**Model:** MHC-C33, TC-WR445

**No. 493**

**Subject:** No Operation of Deck A

**Date:** August 29, 1996

10. REMOVE CAM (A). TURN THE SCREW CLOCKWISE

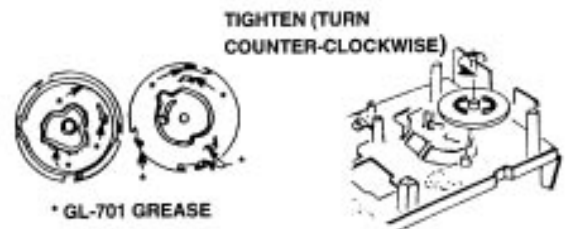
**(161)** The Capstan belt slips due to the excessive load exerted by Cam (A).
